Access Compliance Report

Public Rights-of-Way

(Curb Ramps)

Intersection ID: 50582	Main Street: DOWNY_BIRCH_RD	Cross Street: PAPER_TREE_RD	Location: NW
ADA ID: 9F4F58CB2925	Ramp Type: Perp	Initial Pass/Fail: Fail	Overall Compliance: No
Severity Score: 8.75			
Codes/Mitigation Info/Possible Solution		Field Measurements/Component Compliance

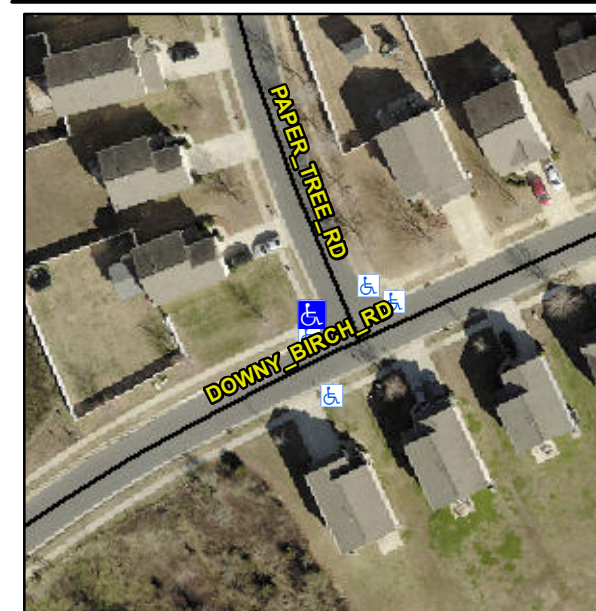
Not Found, R304.5.1

Compliance	Description	Data	Compliance	Description	Data
N/A	Ramp Length (in)	48.5	Yes	Ramp Slope (%)	6.1
No	Ramp Width (in)	47.5	Yes	Ramp XSlope (%)	0.1
N/A	Flare Type LT	N/A	N/A	Flare Type RT	N/A
N/A	Flare Slope LT (%)	N/A	N/A	Flare Slope RT (%)	N/A
N/A	Flare Traversable LT?	N/A	N/A	Flare Traversable RT?	N/A
N/A	Landing Length (in)	N/A	N/A	DWS Provided?	N/A
N/A	Landing Width (in)	N/A	N/A	DWS Contrast?	N/A
N/A	Landing Slope (%)	N/A	N/A	DWS Length (in)	N/A
N/A	Landing X Slope (%)	N/A	N/A	DWS Full Width?	N/A
N/A	Landing Curb? (Y/N)	N/A	N/A	DWS Offset (in)	N/A
N/A	Shared Landing?	N/A			
N/A	Gutter Ponding?	N/A	N/A	Gutter Slope (%)	N/A
N/A	Gutter Lip Ht (in)	N/A	N/A	Gutter X Slope (%)	N/A
N/A	Painted X Walk1?	No	N/A	Painted X Walk2?	N/A
	X Walk 1 Direction	To E		X Walk 2 Direction	N/A
N/A	X Walk 1 Width (in)	N/A	N/A	X Walk 2 Width (in)	N/A
	X Walk 1 Slope (%)	3.1		X Walk 2 Slope (%)	N/A
	X Walk 1 X Slope (%)	2.2		X Walk 2 X Slope (%)	N/A

Remove & Replace Entire Ramp.
